New Lakeport Courthouse Superior Court of California, Lake County

DESIGN BUILD PERFORMANCE CRITERIA DOCUMENTS -
ADDENDUM 7

JUNE 23, 2022

Summary of revisions to the Lakeport Courthouse Criteria Documents dated 3.14.2022:

3.5 SITE PLAN OPTIONS - EAST

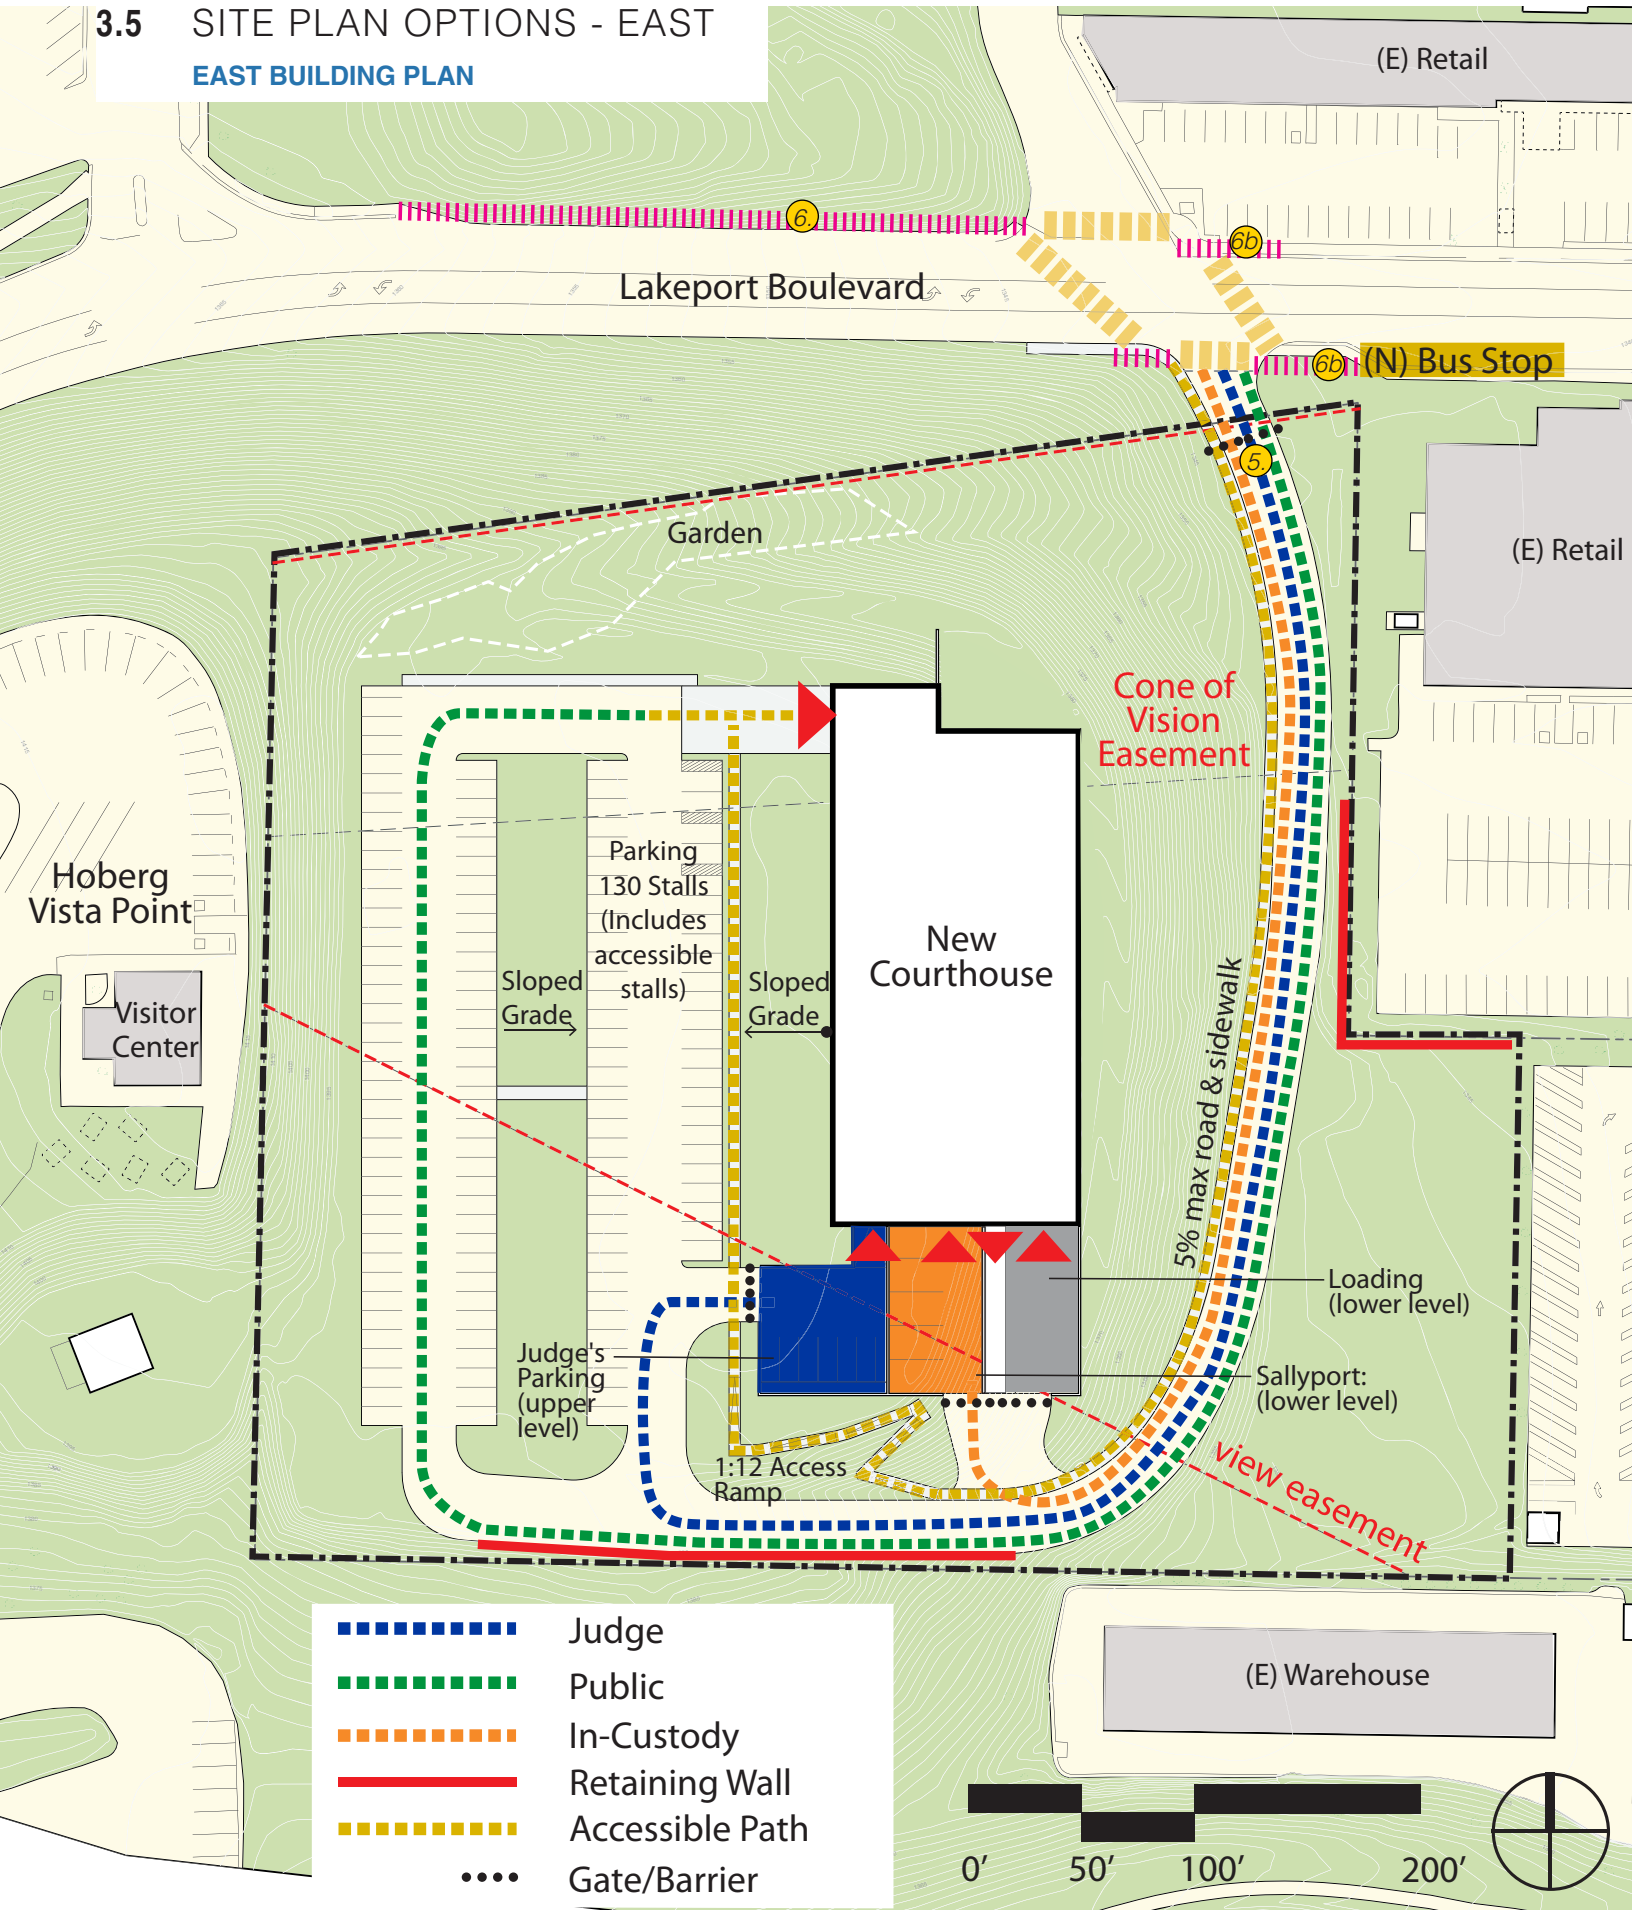
9. 3.4, p. 22, *added Memorandums of Understanding reference.*
10. 3.5, p. 24, *added bus stop and sidewalk improvement notes on Lakeport Boulevard.*

11. 3.5, p. 25, *added keynotes 6 and 6B. 14*
12. 3.5, p. 28, *added Memorandums of Understanding reference to Project Documents.*
13. 3.6, p. 30, *added bus stop and sidewalk improvement notes on Lakeport Boulevard.*

1. JUDGES PARKING (LOWER LEVEL) -- COVERED/SCREENED
2. SALLYPORT (LOWER LEVEL) -- 5 VAN STALLS AT 15' X 24', SCREENED
3. SERVICE LOADING (UPPER LEVEL) -- SCREENED
4. SECURITY GATE/BARRIER
5. VEHICLE GATE AT SITE ENTRANCE
6. PUBLIC BUS STOP (6b) AND SIDEWALK IMPROVEMENTS PER CITY STANDARDS

NORTH BUILDING PLAN

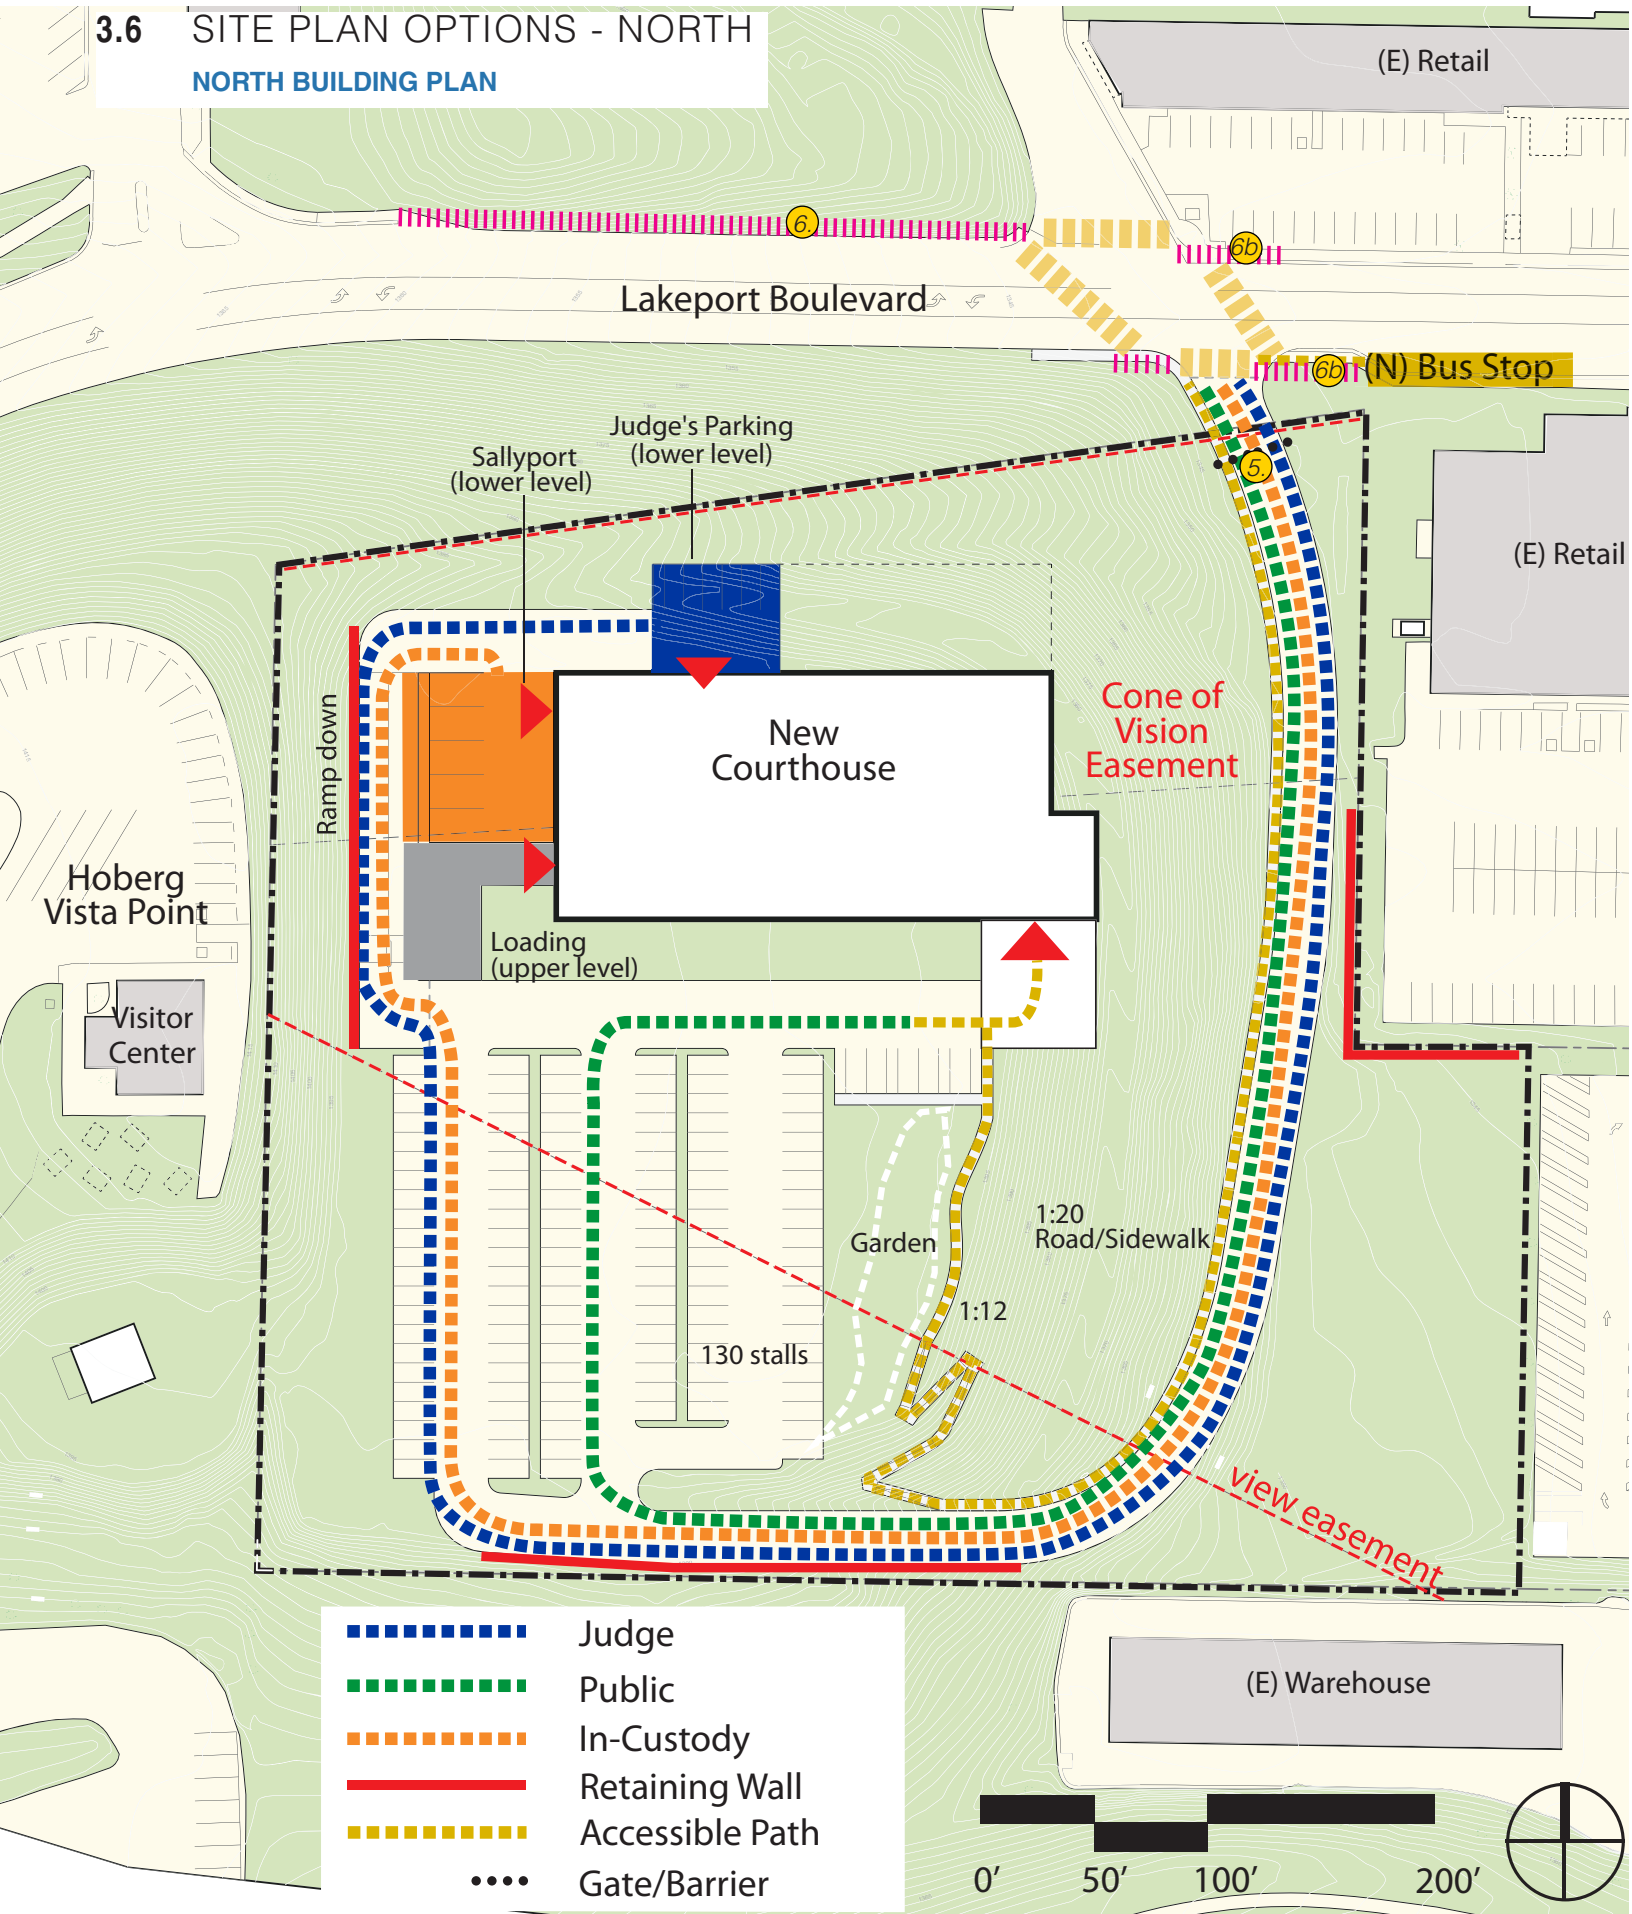
14. 3.6, p. 31, *added bus stop and sidewalk improvement notes on Lakeport Boulevard.*
15. 3.6, p. 34, *added Memorandums of Understanding reference.*
16. 3.7, p. 37, *added 3.7.12 Hydrology report and 3.7.13 and Lakeport Boulevard sidewalk improvements.*

4.2.2 Blocking and Stacking - Upper (Public Entry) Level

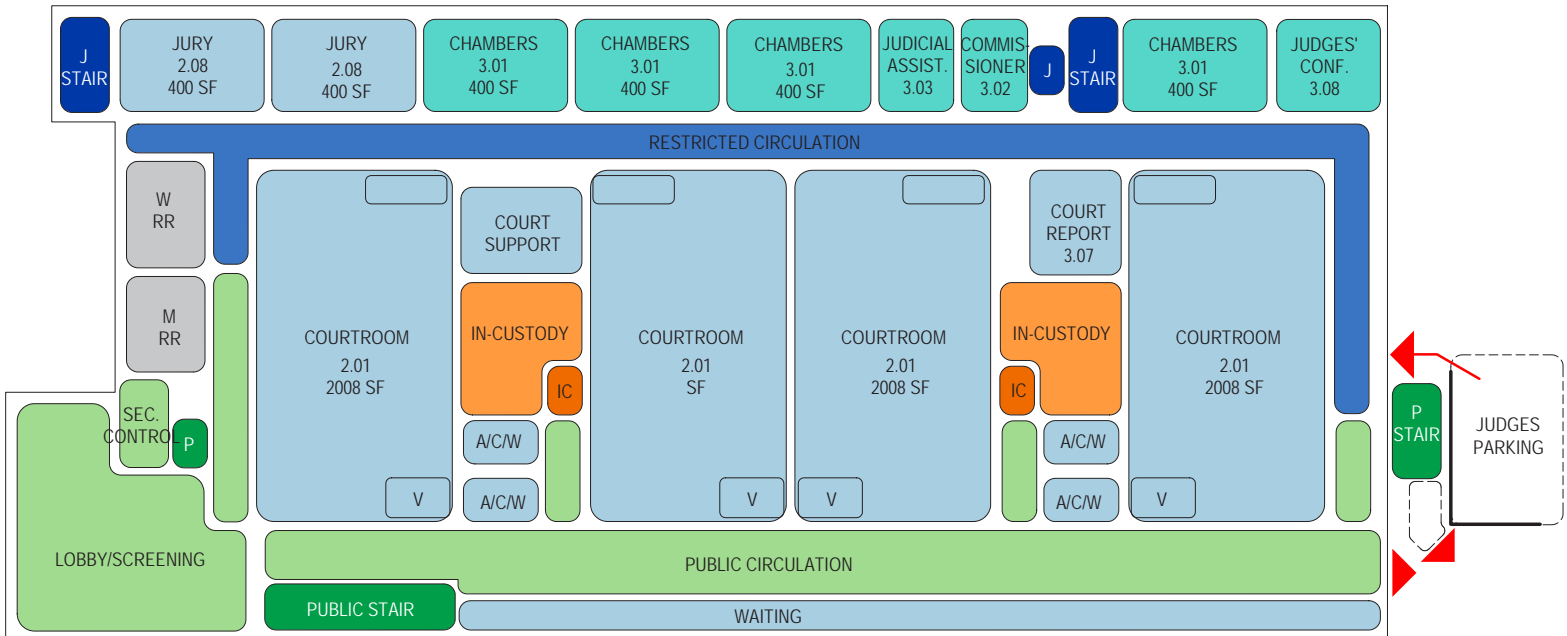
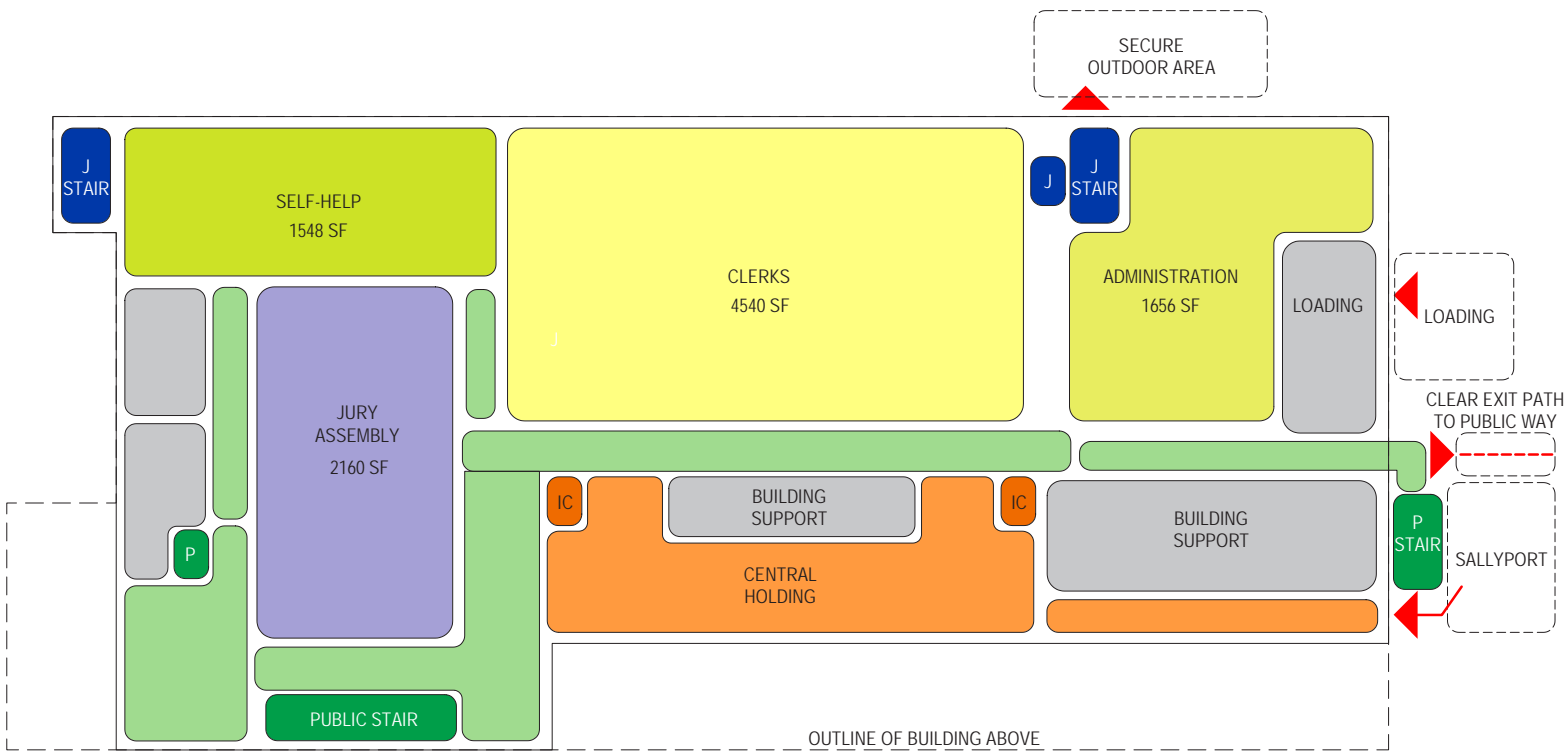
17. 4.2.2 p. 62: *added note for four exit stair locations and widths pending OSFM approval.*
18. 4.2.2 p. 62-63: *added fourth exit stair at Entry Level and Lower Level Diagrams.*

- Plan current spaces and infrastructure with flexibility to accommodate workstation densification or future growth without excessive rework.
- Choose MEPT systems judiciously for modular expansion of capacity. Plan support space for expansion.
- Provide capacity for routing of future conduit/pipe or duct runs as feasible.
- Four exit stair locations and widths pending OSFM approval.

4.2.2 Blocking and Stacking - Axonometric

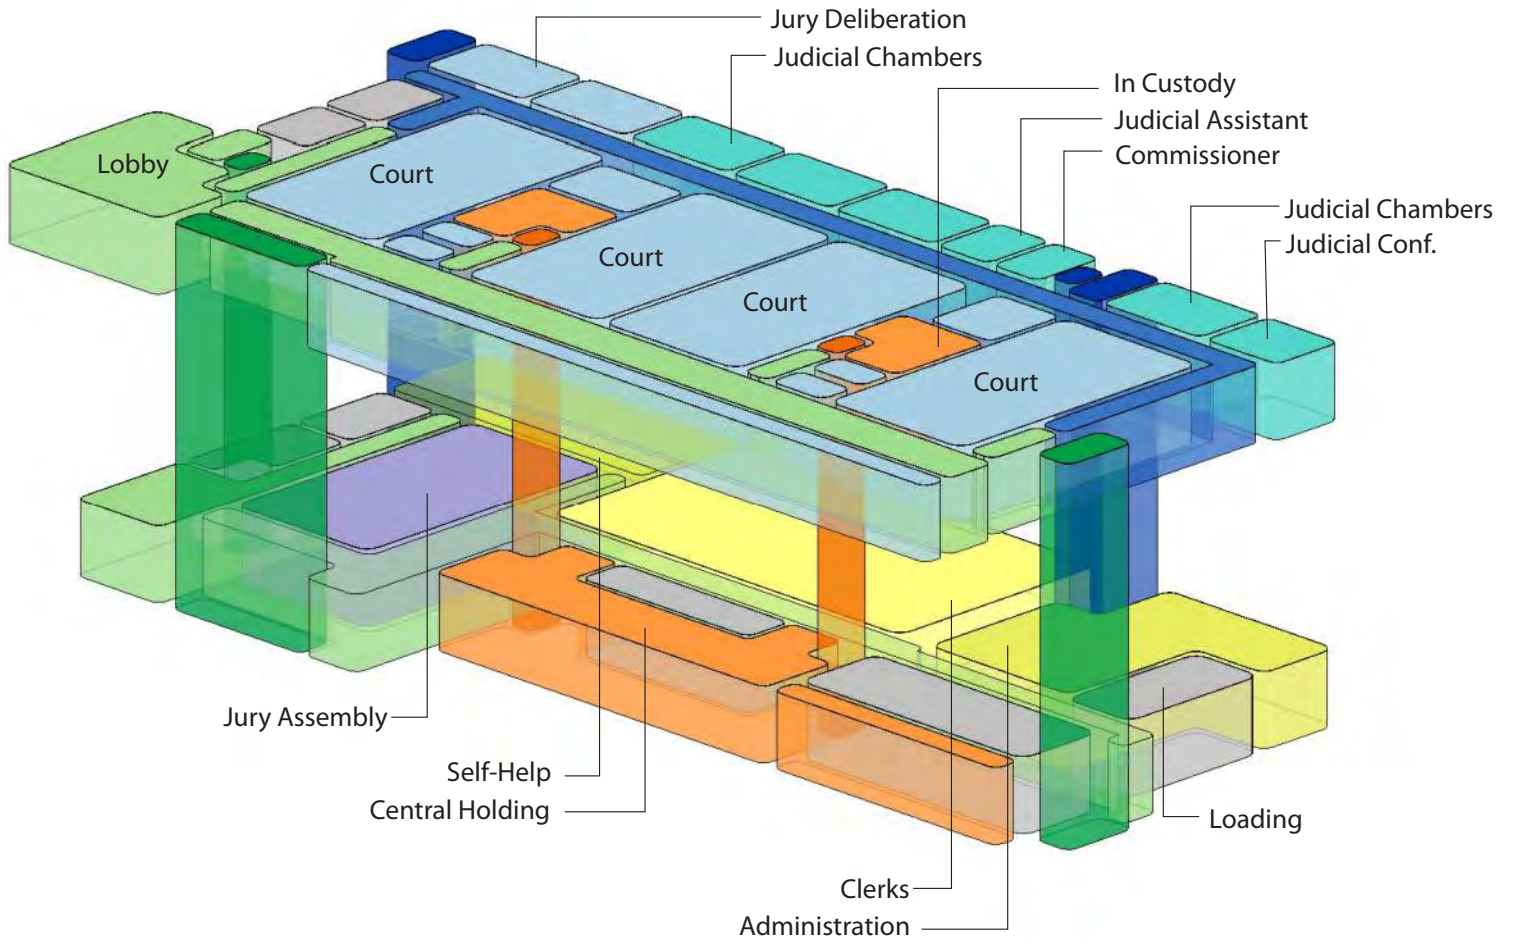
19. 4.2.2. p. 64: *added fourth exit stair in Axonometric.*
20. 8.2 p.108: *notes the Addendum to MND with Biological Study, Jurisdictional Waters and Cultural Resources Plan.*
